Final Environmental Impact Statement

**Ox Mountain Sanitary Landfill
Apanolio Canyon Expansion Site
San Mateo County, California**

Volume I - Final EIS and Response to Comments

**US Army Corps
of Engineers**
San Francisco District

3.5-7

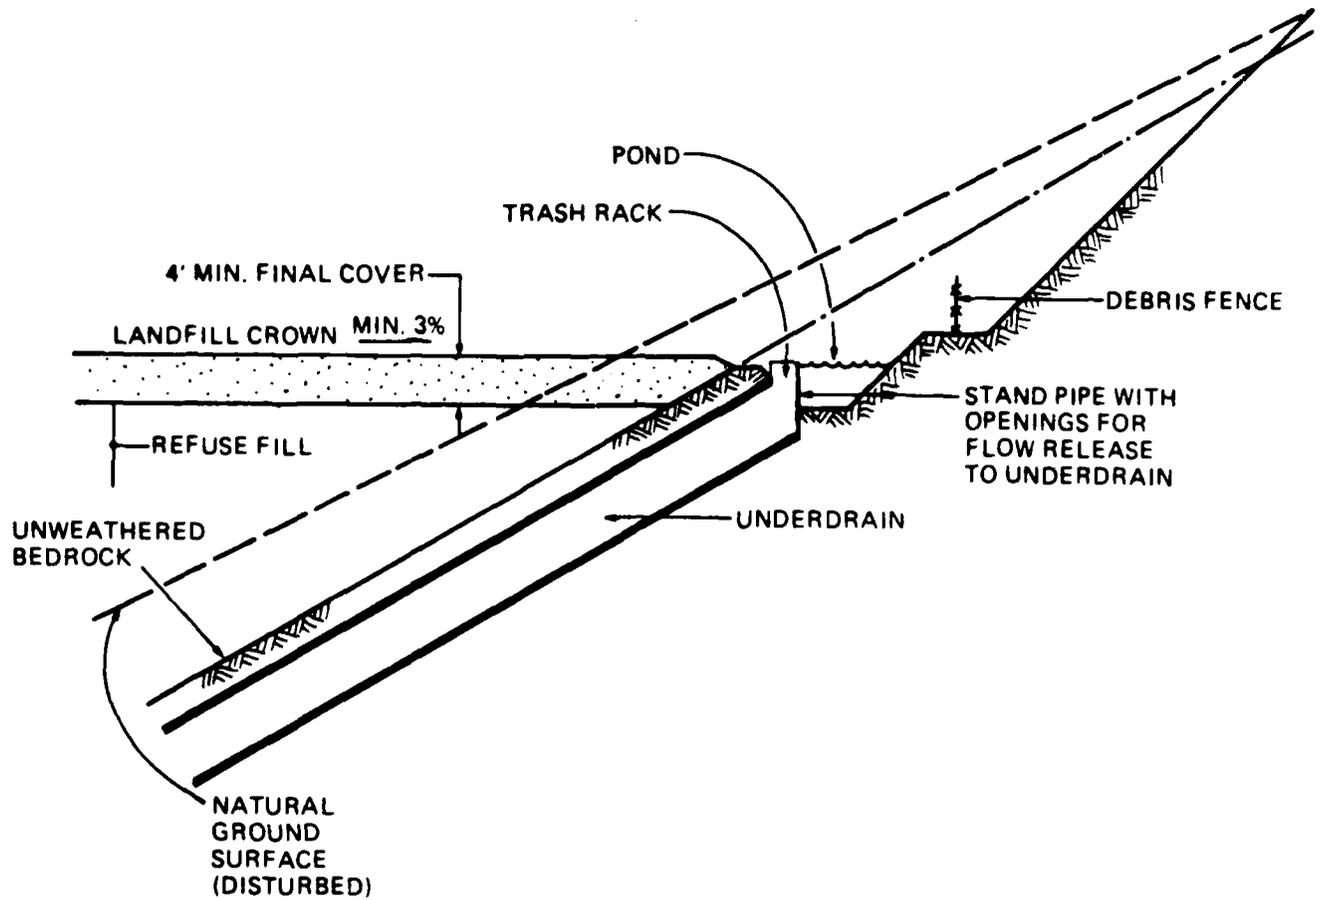
The design of the clay liner and leachate collection blanket, as shown in Figure 3-4-7 (page 3-36), does not appear to be appropriate given the high angles of the natural slopes. It would be very difficult, if not impossible, to install a 12-inch clay liner on a 2:1, or even up to a 1:1, slope in the canyon area. The revised draft EIS should substantiate any claims as to the constructibility of this liner and collection system, and anticipated construction and quality control problems.

8. Page 3-39. The description of the collection system for the use of filter fabric surrounding the filter rock overlying the bedrock is not shown in Figure 3-5-7 as stated. Revise the figure to include the filter fabric.

33-8. See revised EIS Figure 3.5-7, which shows filter fabric for the ground-water collection system.

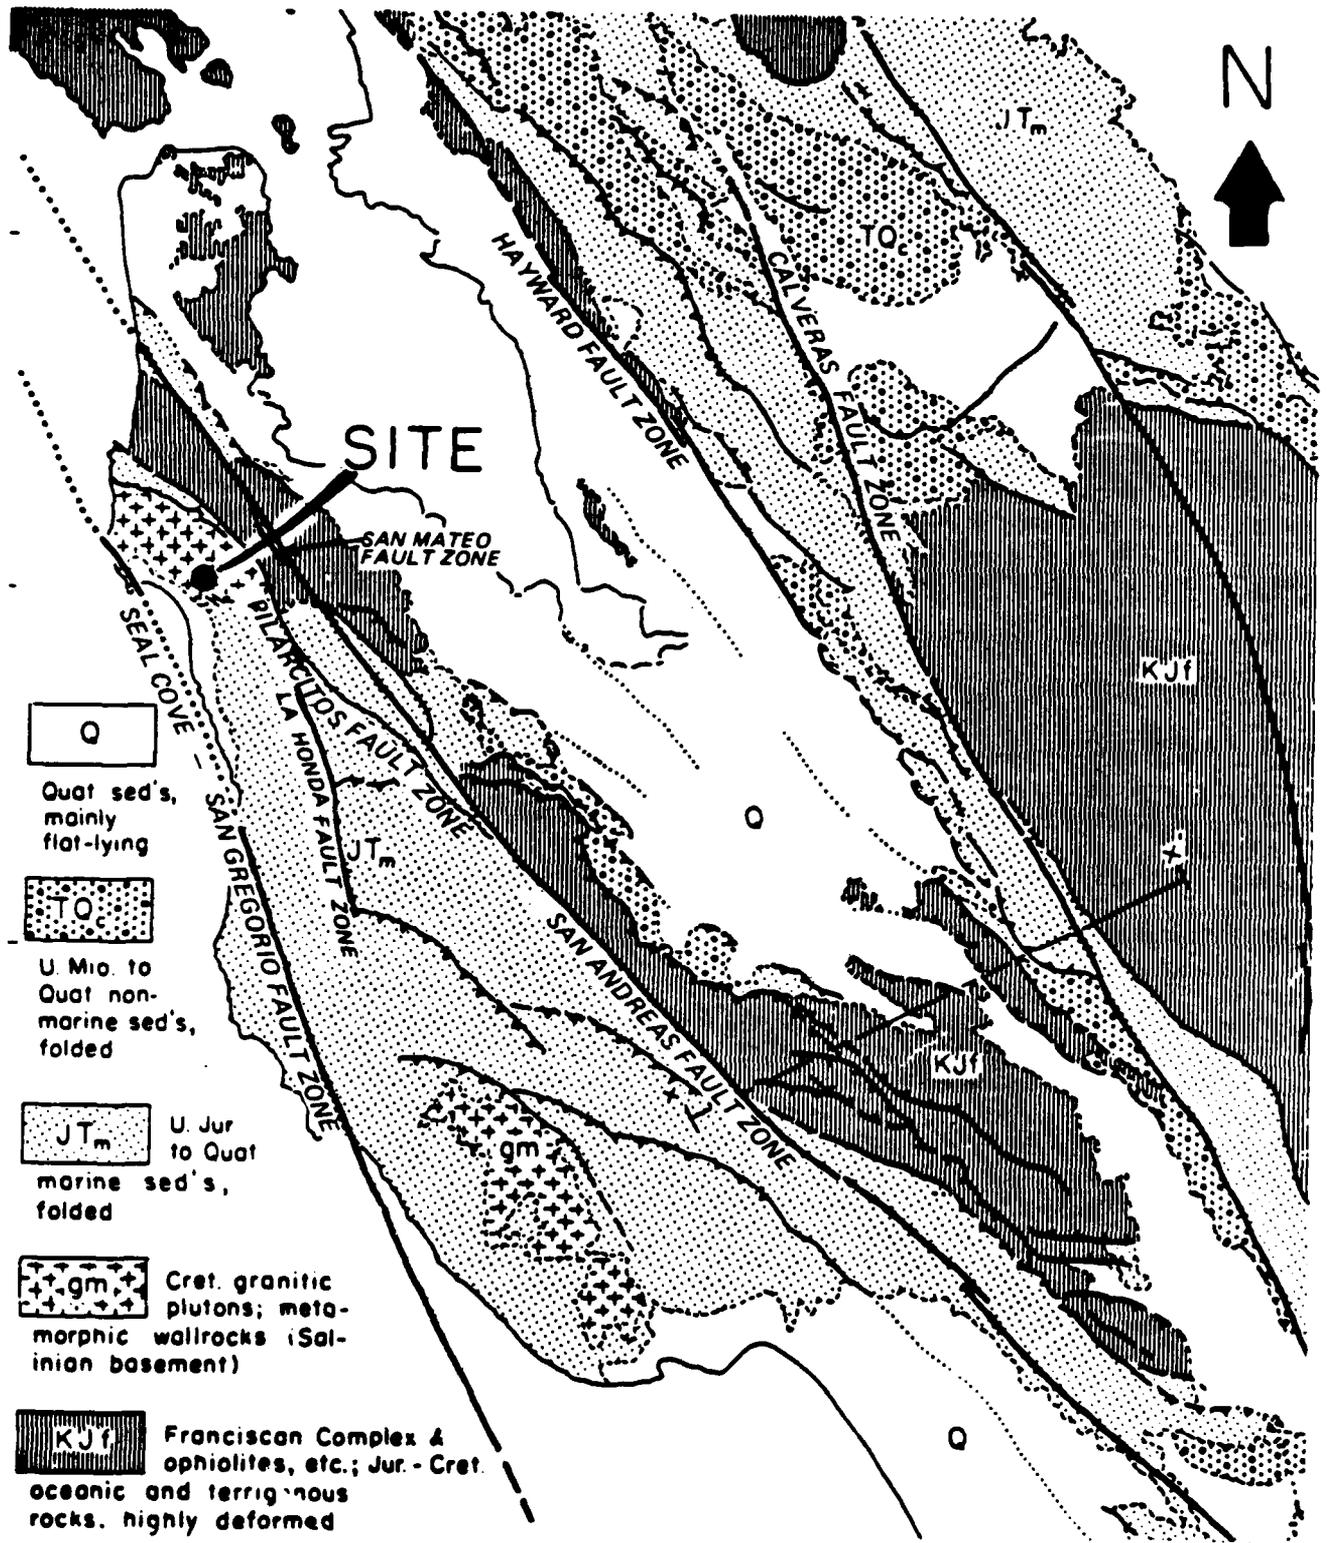
Potentially active faults are listed as the Pilarcitos, San Mateo, and La Honda faults. It is stated in the draft EIS (page 4-3) that the potential for severe ground shaking from potentially active faults at Apanollo Canyon is less than for the recognized active faults. However, no justification for this determination is provided. The San Mateo and La Honda faults are not indicated on a location map (e.g., Figure 4.1-1).

5-55. Justification is based on USGS and CDMG published data used by others in the profession. Basis for this justification would include: 1) Activity level of the faults (Pilarcitos, San Mateo, and La Honda faults are not considered active, whereas the San Andreas, Hayward and Calaveras faults are classified active - last 10,000 years - and have also been active historically - last 200 years -); 2) length of fault; and 3) recurrence interval. Figure 4.1-1 has been revised to indicate the location of the San Mateo and La Honda faults.

4.1-3

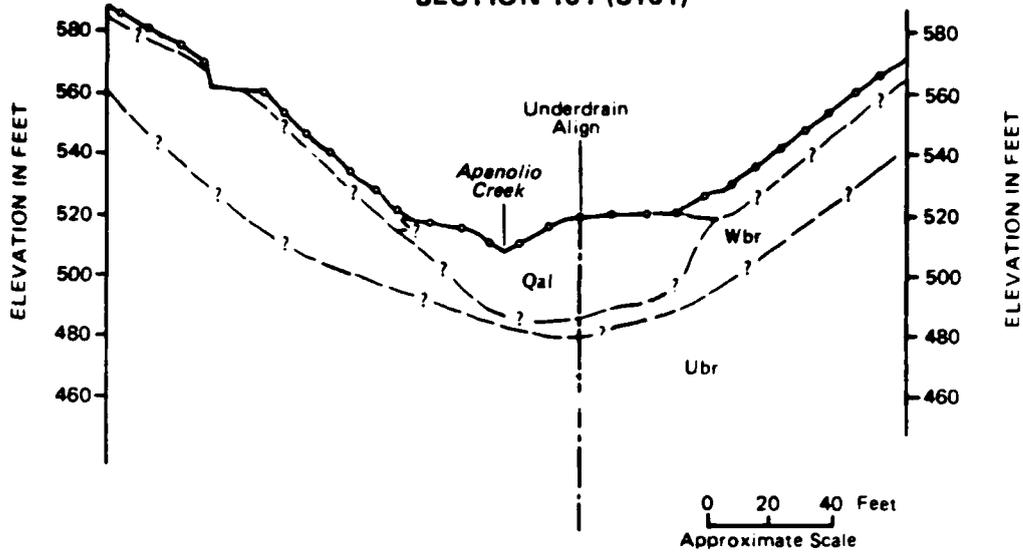
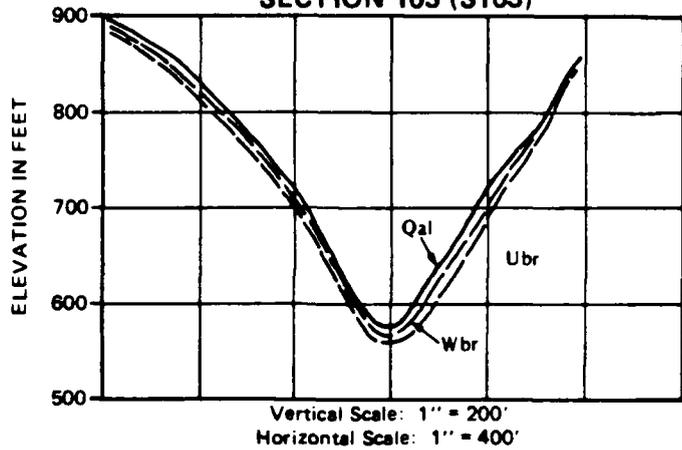
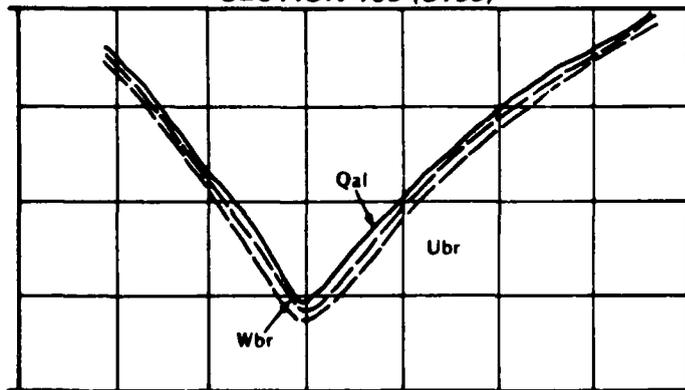
The geological cross sections discussed in Section 4.1(b) are not described adequately (see page 4-7, paragraph 3). Were the cross sections generated from actual borings? If so, the locations of the borings should be depicted in Figure 4.1-3 along the cross section. Section 10) of Figure 4.1-4 (page 4-9) shows weathered and unweathered bedrock, as well as the recent alluvium/colluvium, with dashed lines. If these cross sections were generated from borings, why are they shown as dashed lines? The revised draft EIS should present specific locations for borings on the slopes of the canyon, as well as elevations of weathered and unweathered bedrock and groundwater levels.

5-32. The geologic cross sections illustrated in Figure 4.1-4 were constructed using data obtained from geologic surface mapping, and monitoring well and geologic boring data generated during geotechnical investigation of the canyon. Figure 4.1-3 (Revised) of the EIS shows the location of borings made within Apanolio Canyon. Appendix D contains summary data on locations and elevations of borings. The cross sections presented in Figure 4.1-4 show geologic contact lines, dashed where approximate and question marked where uncertain which is a standard in the profession.
